As-Built Review

RE: Gladys E. Kelly Public Library, 2 Lake Street, Webster, Massachusetts

- Item 1. Two (2) sheets entitled "As-Built Plan, Gladys E. Kelly Public Library, 2 Lake Street, Webster, Massachusetts 01570", dated December 11, 2018, revised January 17, 2019, prepared by BC Engineering & Survey, Inc.
- Item 2. Letter dated March 18, 2019, prepared by BC Engineering & Survey, Inc., "Subject: As Built Plan Peer Review Letter"

SUBJECT: As-Built Plan Peer Review Letter
Dated: January 7, 2019

AS - BUILT PLAN
GLADYS E. KELLY PUBLIC LIBRARY
2 LAKE STREET
WEBSTER, MASSACHUSETTS 01570

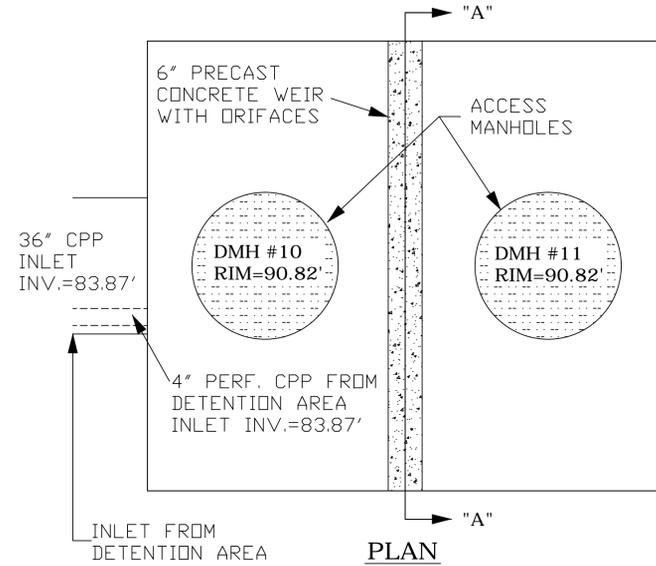
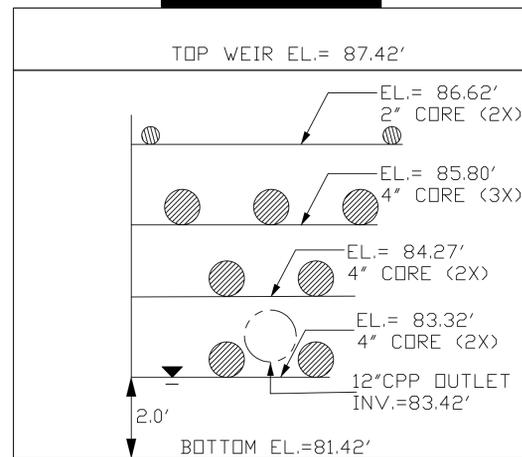
- The as-built information for the detention system outlet structure must be reviewed. The information provided does not match the approved plan set. The Contractor and Surveyor must coordinate to determine if this is an installation error or a survey error.
- The sidewalk ramp on the east side of the exiting driveway on Negus Street must be corrected to satisfy MA AAB and Webster requirements.

7.) The sidewalk ramp on the east side of the existing driveway on Negus Street exceeds the Webster and AAB standards of 8% maximum slope.

Response: Item shall be addressed by M. O'Connor Contracting, Inc..

SECTION "A" - "A"
OUTLET CONTROL STRUCTURE (OCS102)
AS-BUILT ELEVATION DETAIL
(NOT TO SCALE)

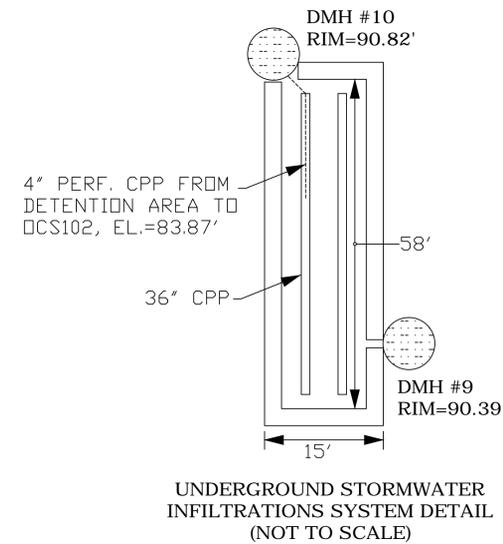
- 6.) DMH #10 and #11 as labeled on the As-Built Plan is the meter structure from the detention system. The surveyor should review the inverts for the orifices and weir in this structure as they do not match the approved plan. Orifices should be reported with the number of orifices, diameter and invert.

Response: Revised plan, outlet control structure (OCS102) detail shown on sheet 2 of 2 including number, diameter and inverts.
